Revision/	Description/Description	Date/Date
ADDENDUM NO. 2		2015/03/20
0	ISSUED FOR TENDER	2014/12/19

Project title/Titre du projet
ESQUIMALT GRAVING DOCK
 825 ADMIRALS ROAD, VICTORIA, BC

ESQUIMALT GRAVING DOCK WATERLOT PHASE 2 SOUTH JETTY UNDER-PIER SEDIMENT REMEDIATION

Drawing title/Titre du dessin
EXISTING CONDITIONS AND GEOTECHNICAL INFORMATION

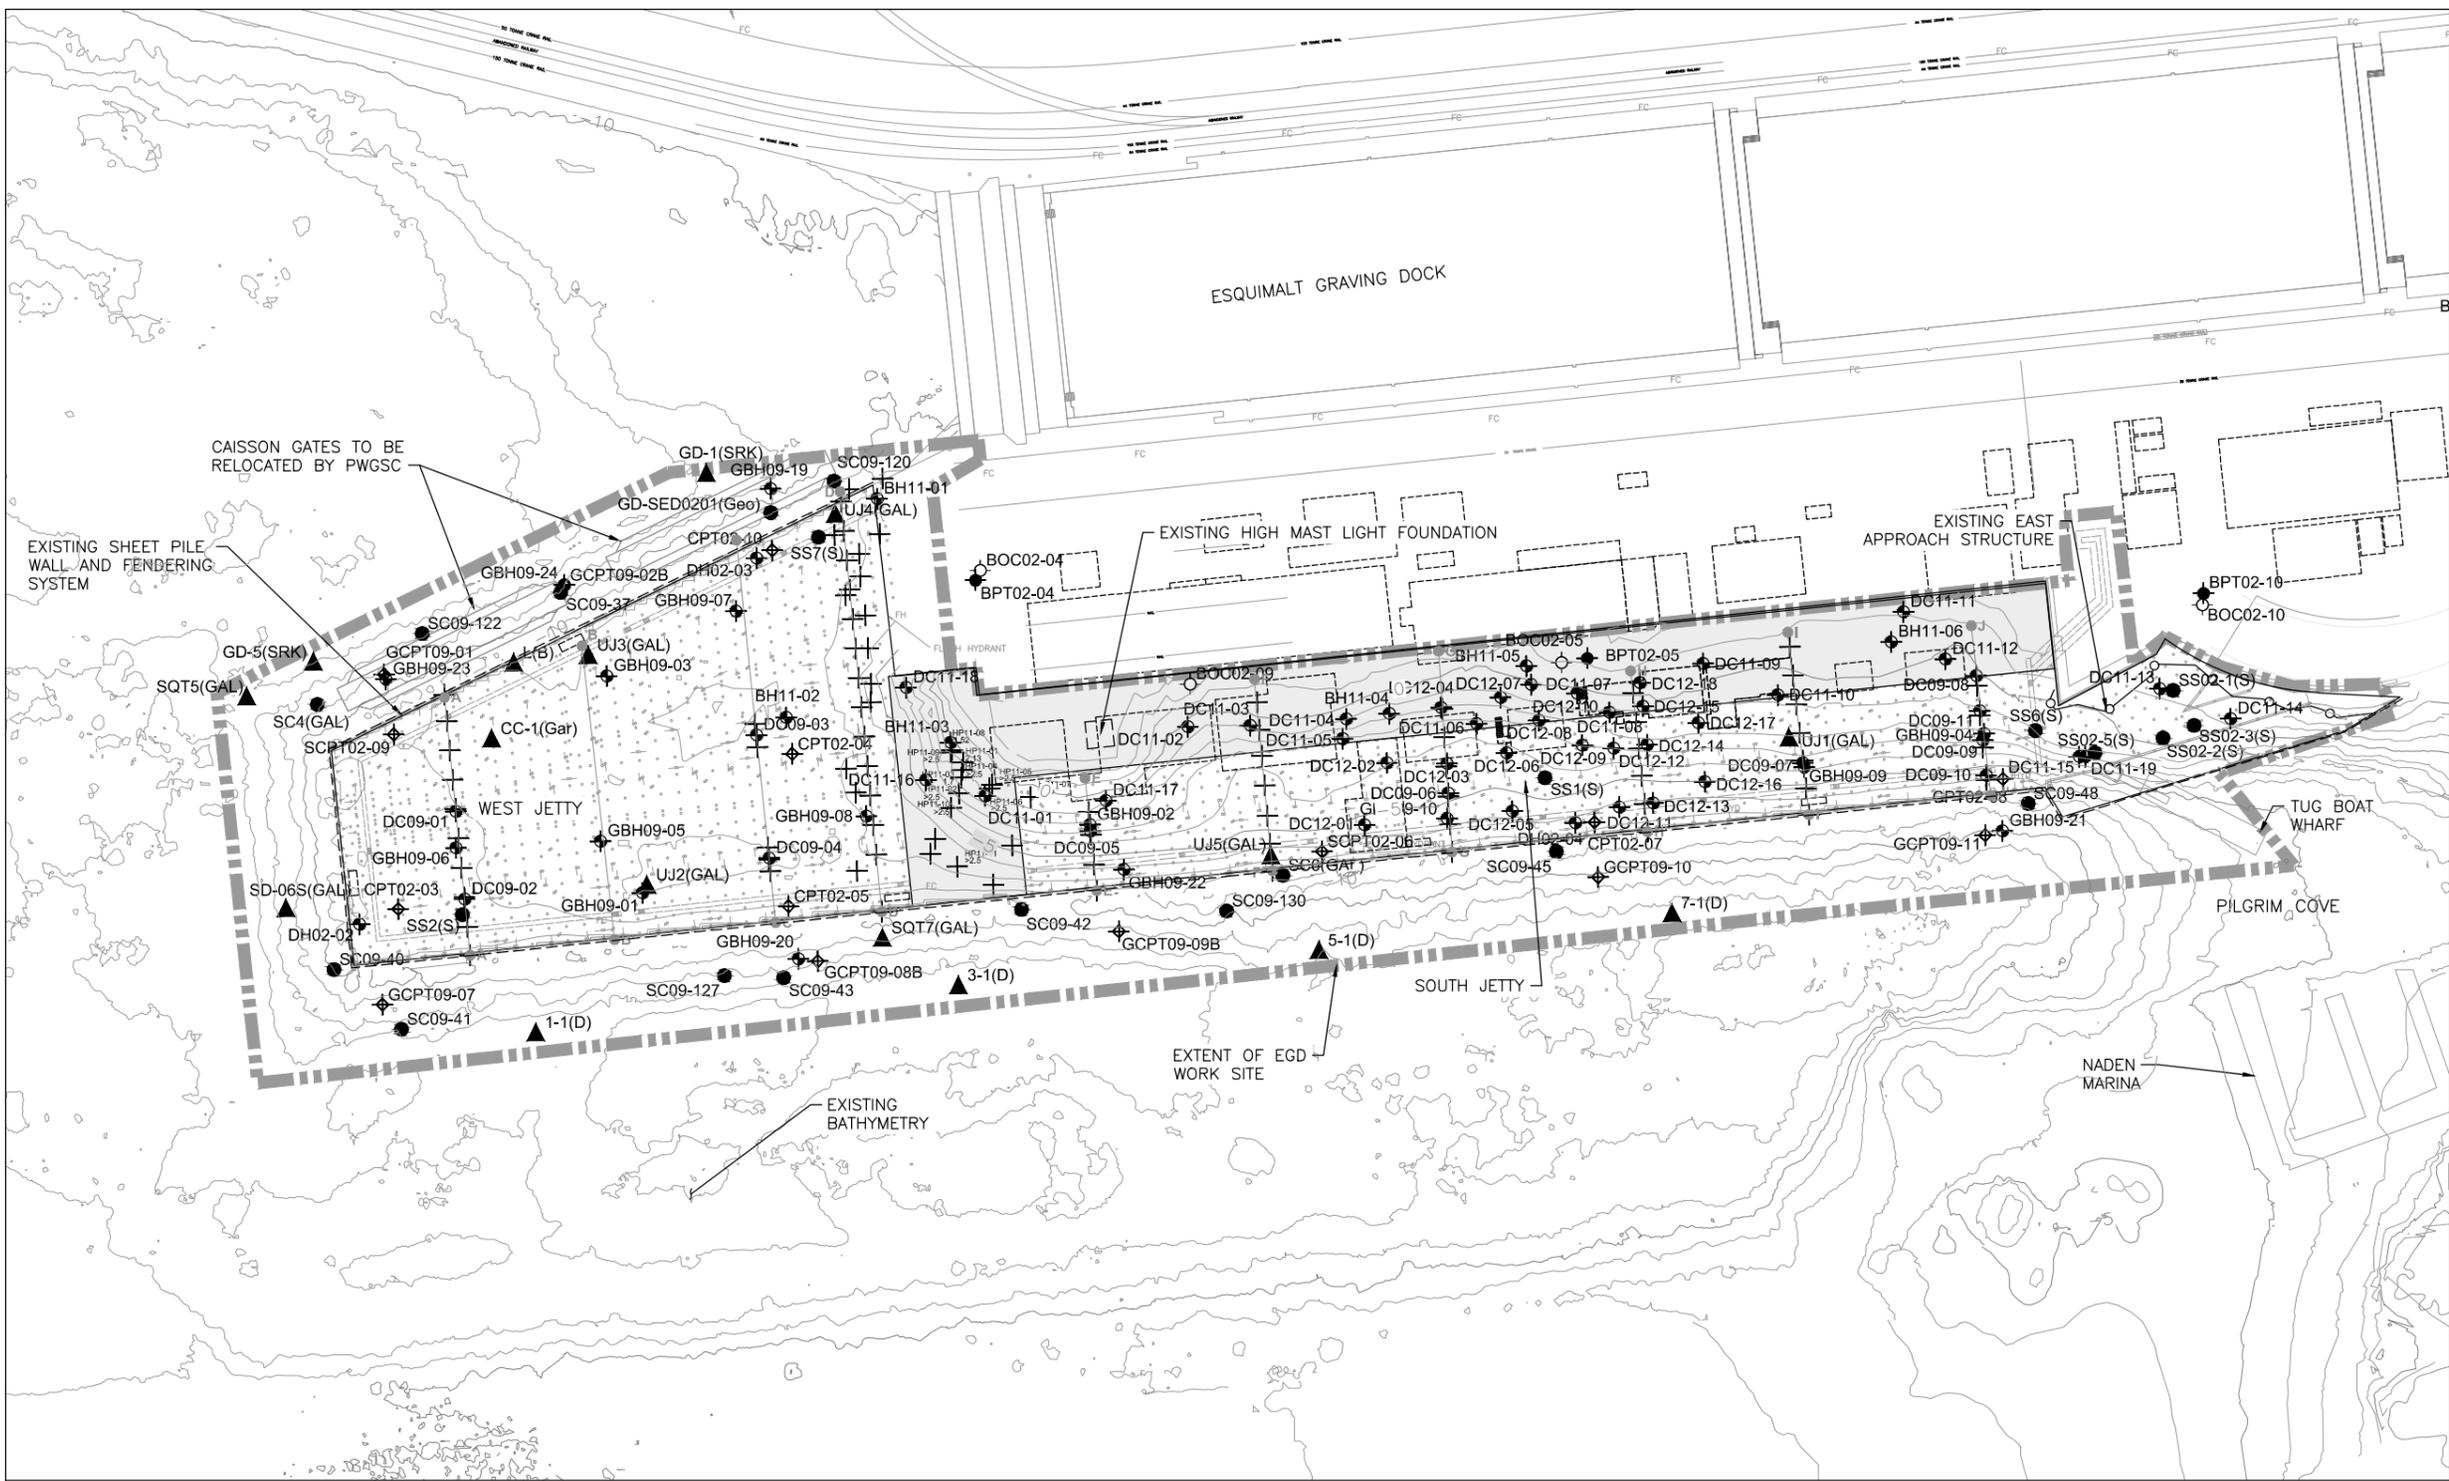
PREVIOUS NOTE 4 DELETED

Drawing title/Titre du dessin
**CONTRACTOR'S WORK AREA
AND SITE ACCESS**

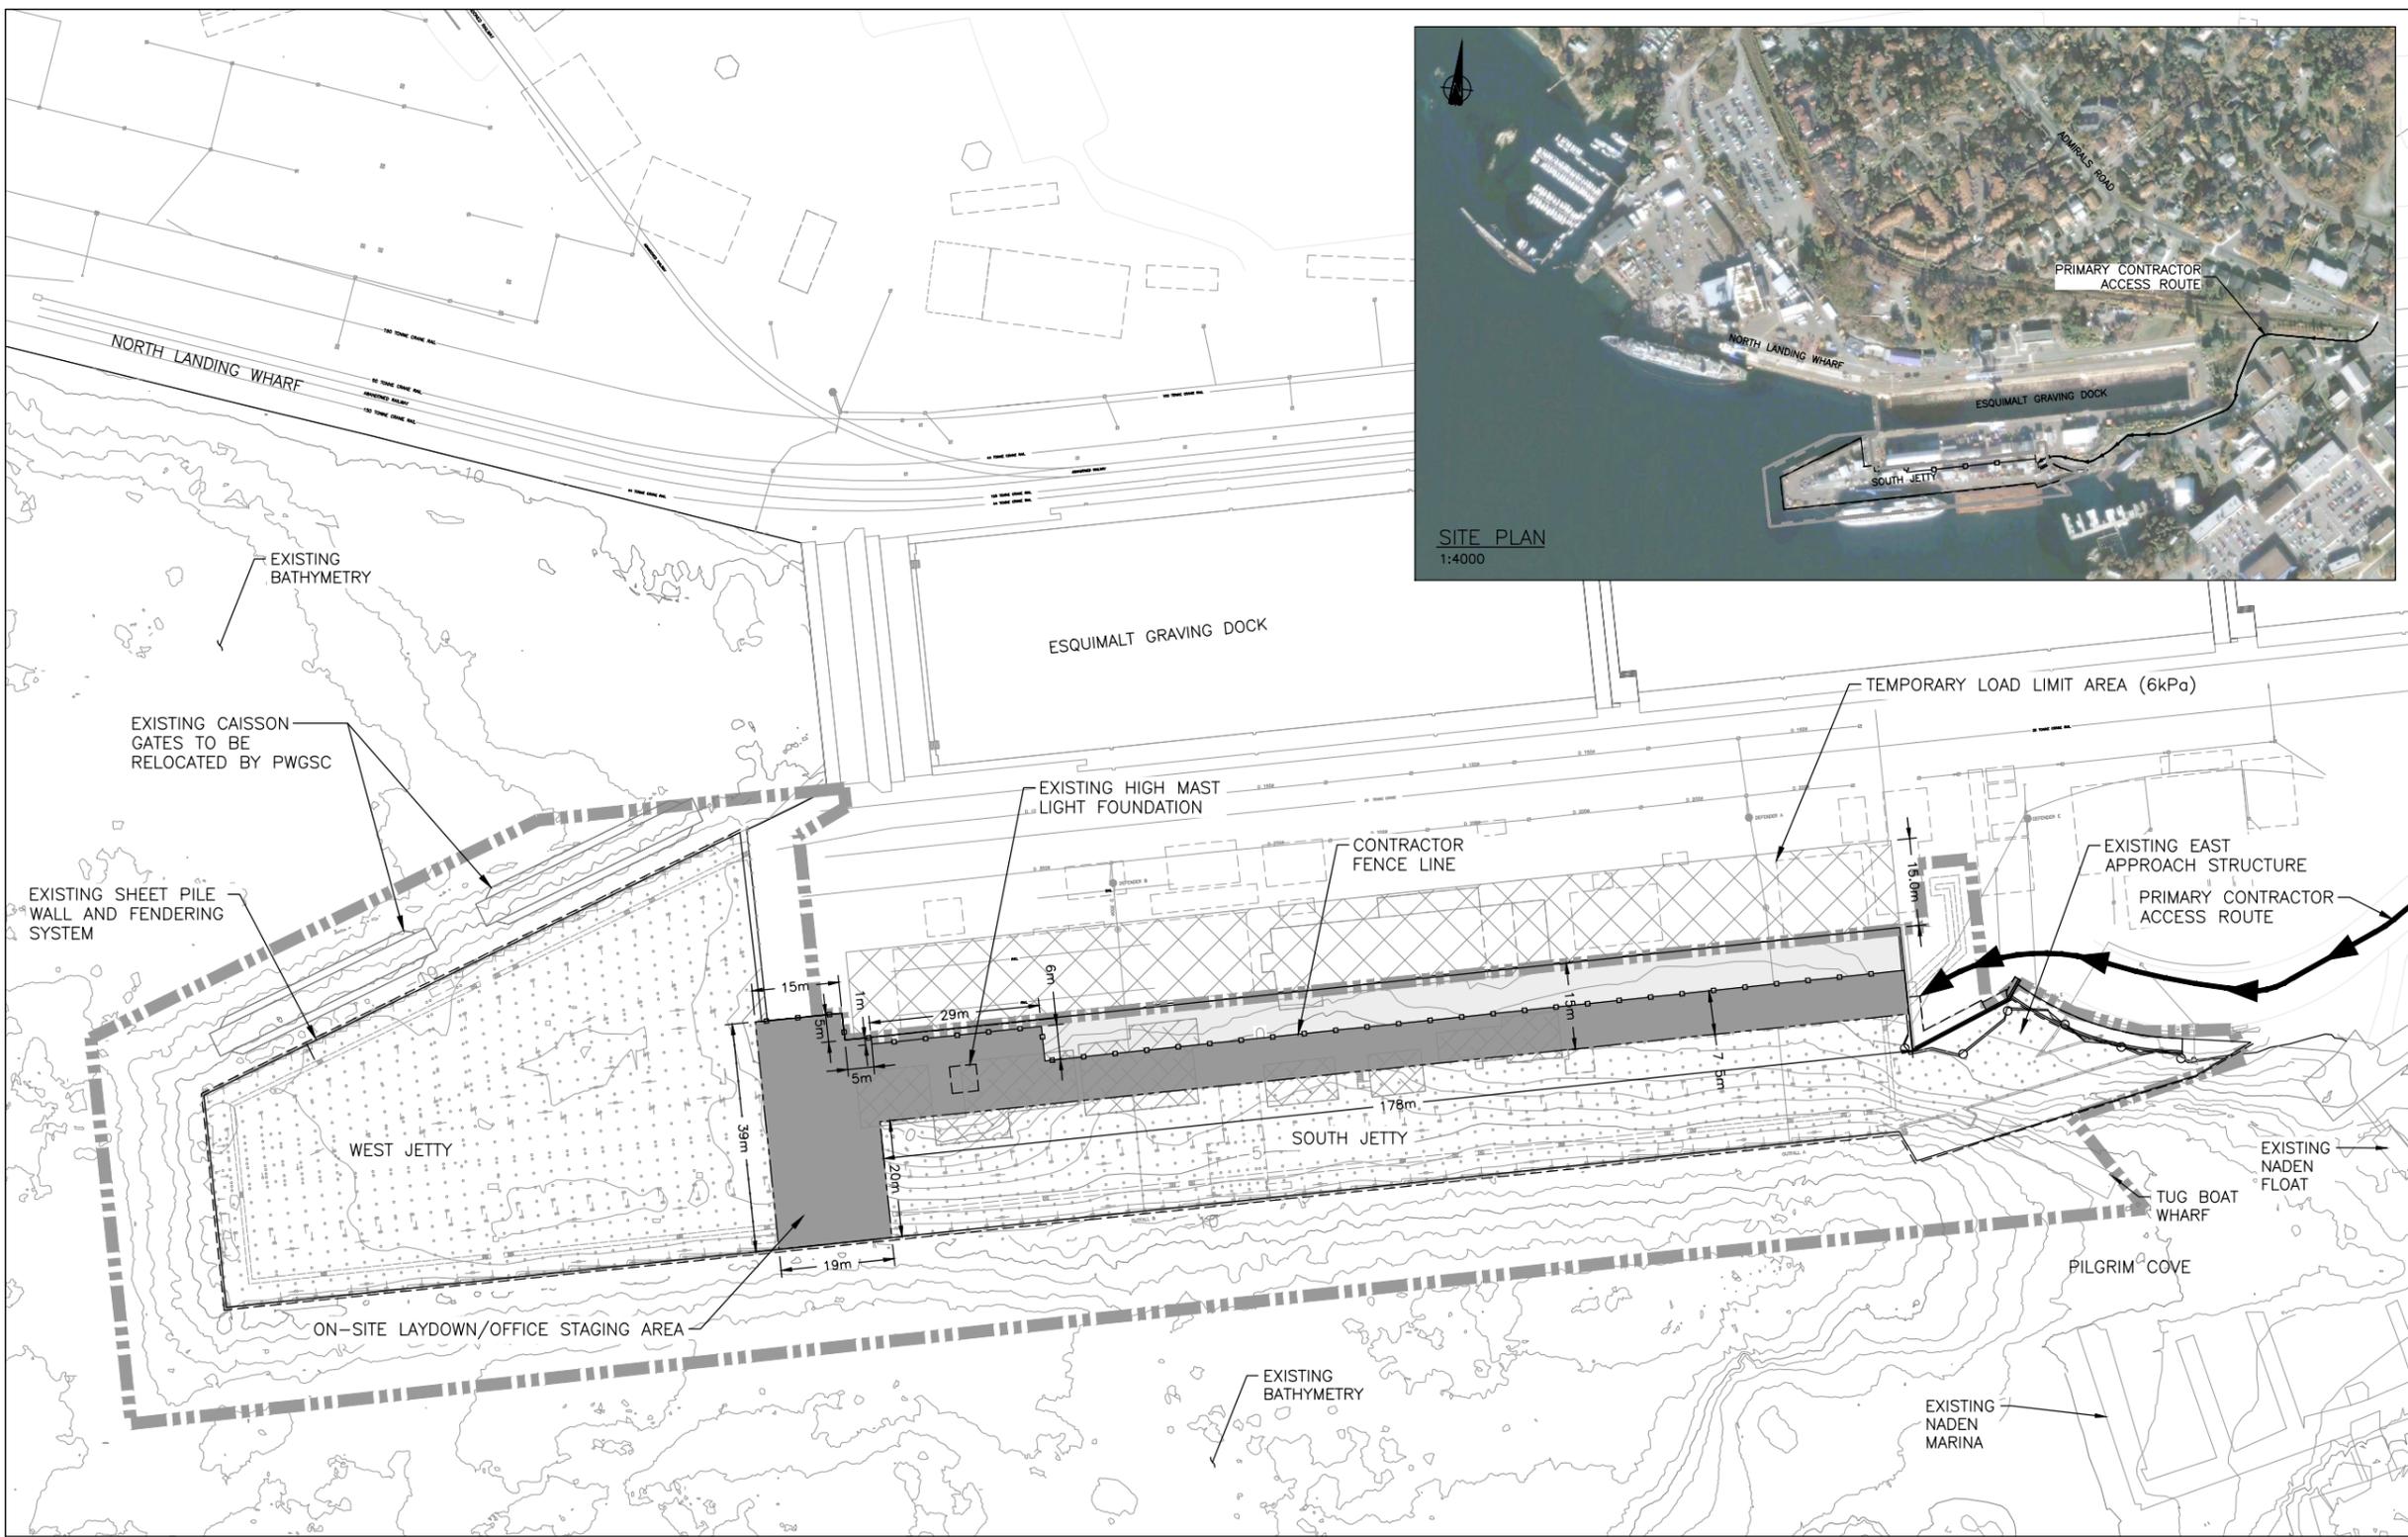
PREVIOUS NOTE 4 DELETED

- CONTRACTOR SHALL PROVIDE A 12.2-METRE BY 6.1-METRE (APPROXIMATELY 74m²) AREA WITHIN THE CONTRACTOR STAGING AREA FOR THE DEPARTMENTAL REPRESENTATIVE'S CONSULTANT TEAM TRAILER AT THE REQUEST OF THE DEPARTMENTAL REPRESENTATIVE.

- CONTRACTOR SHALL NOT OBSTRUCT BUILDING ACCESS ADJACENT TO THE CONTRACTOR ON-SITE STAGING AREA.

Drawing title/Titre du dessin
ENGINEERED CAPPING PLAN

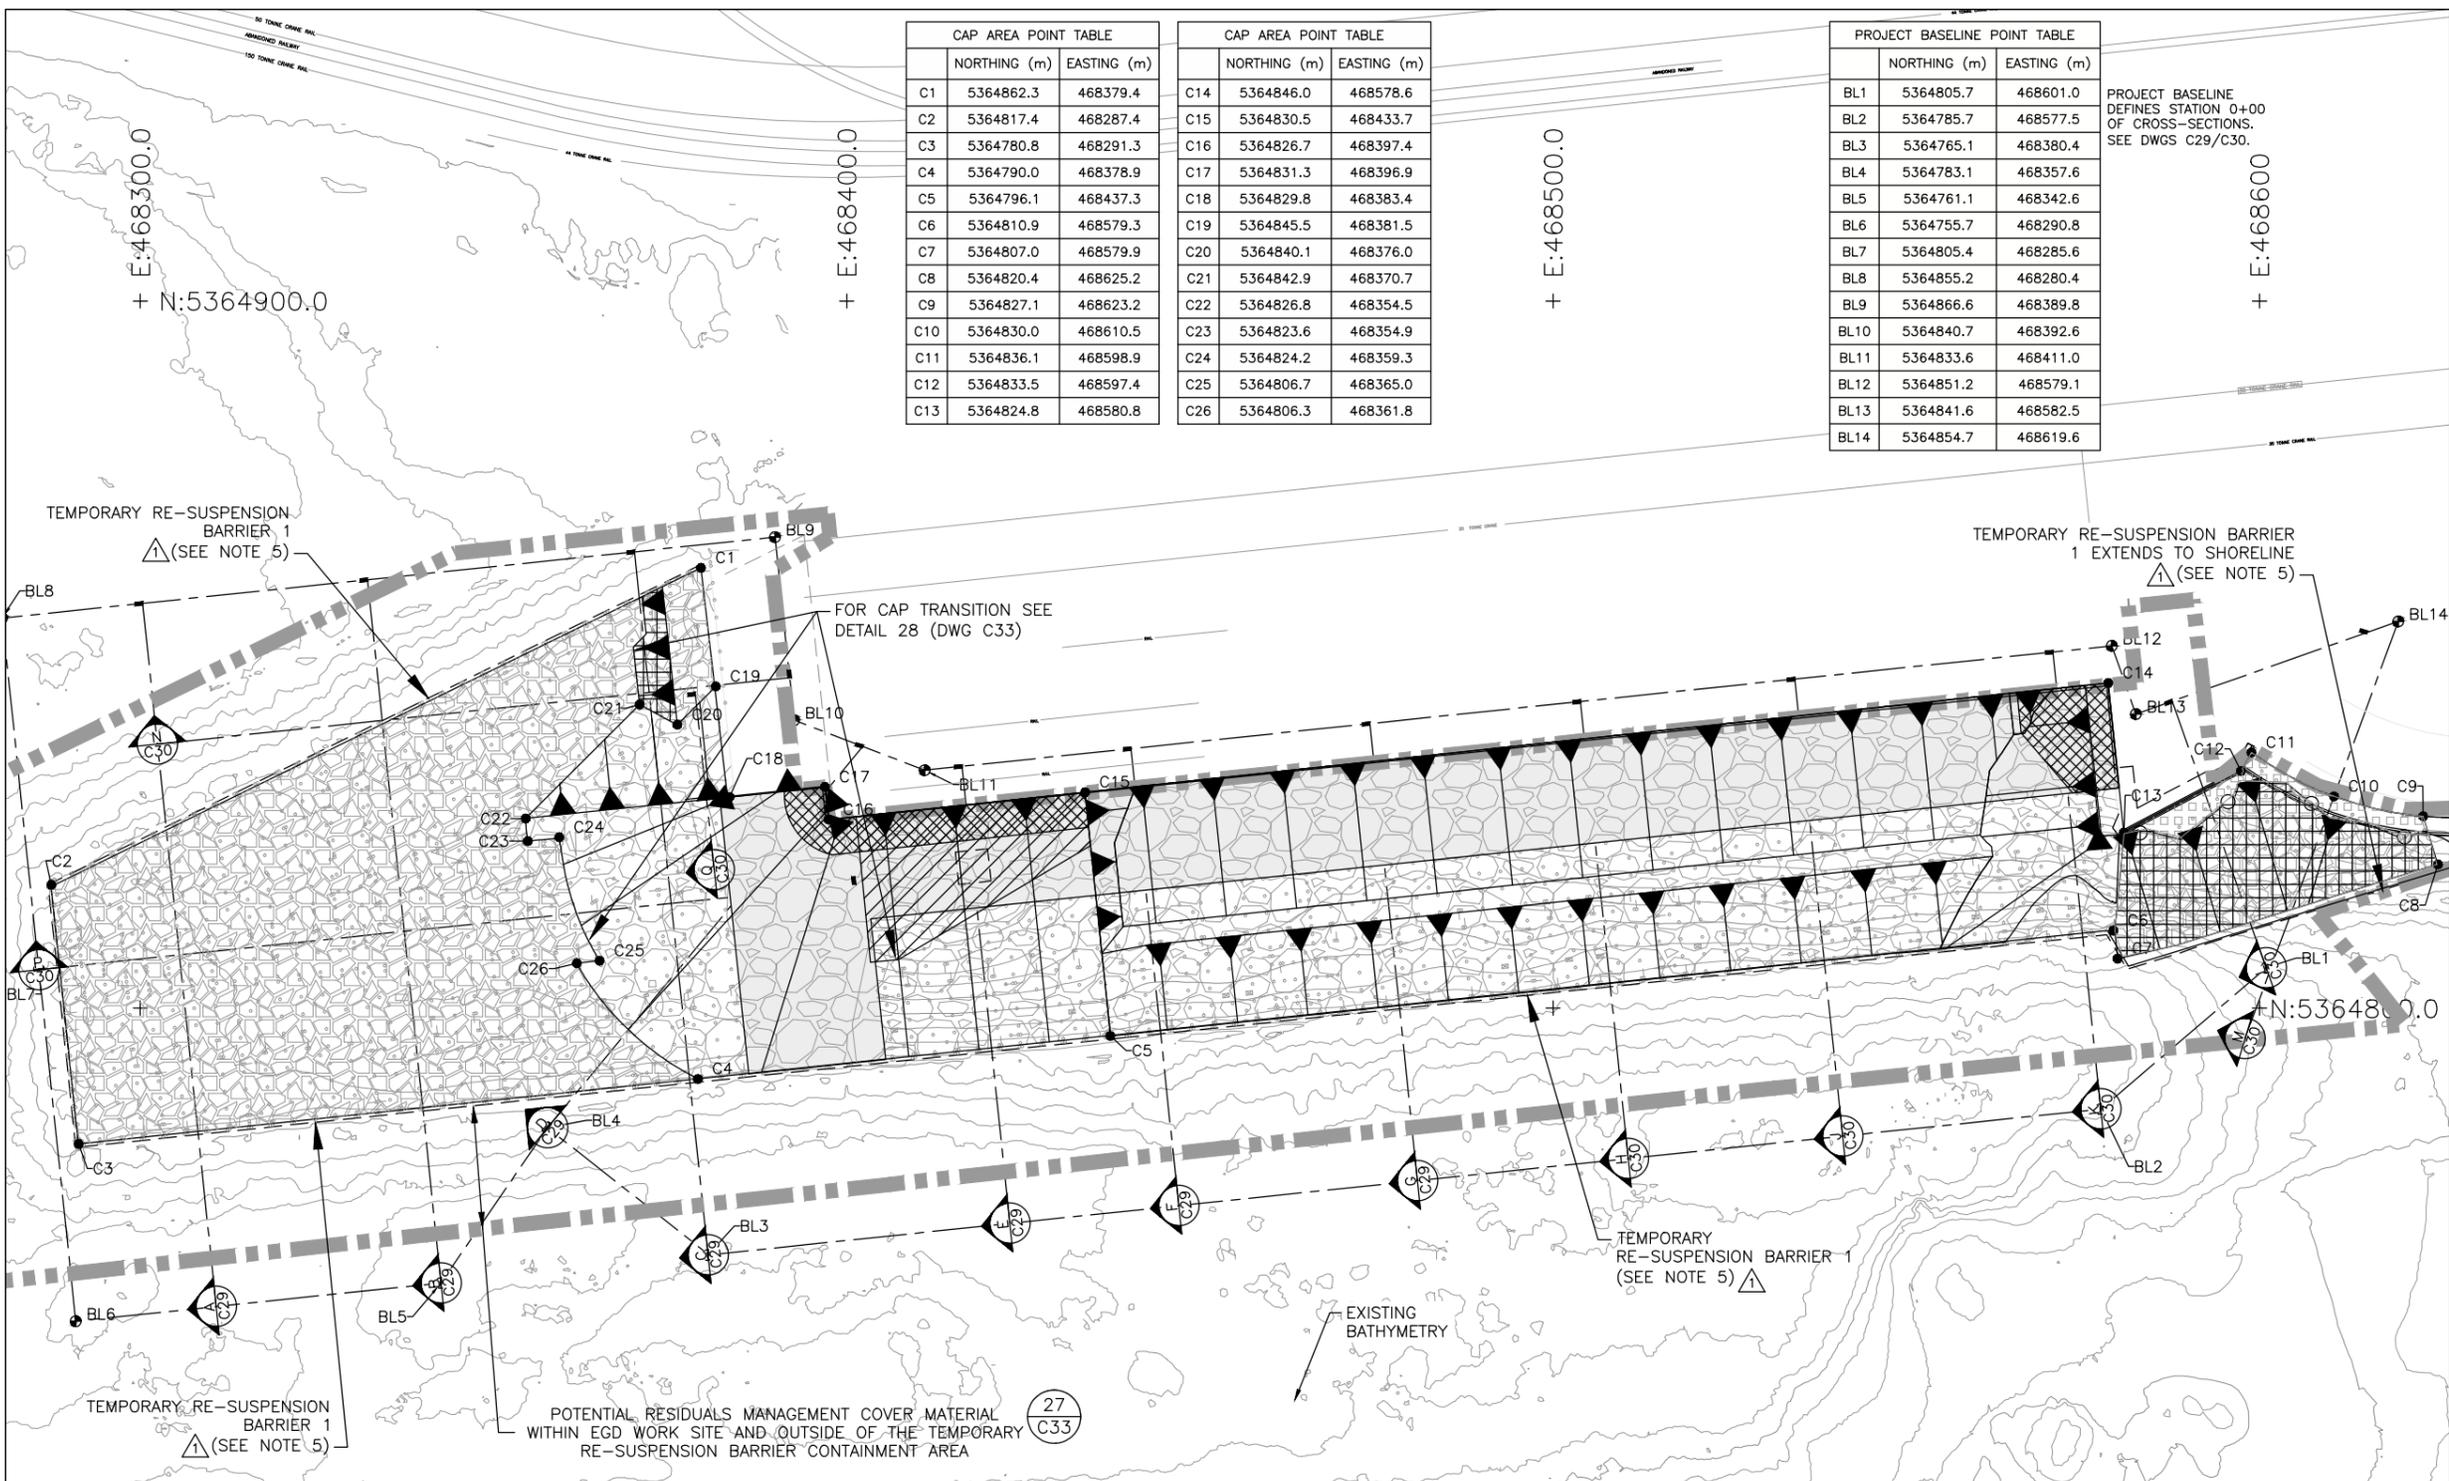
PREVIOUS NOTE 3 DELETED
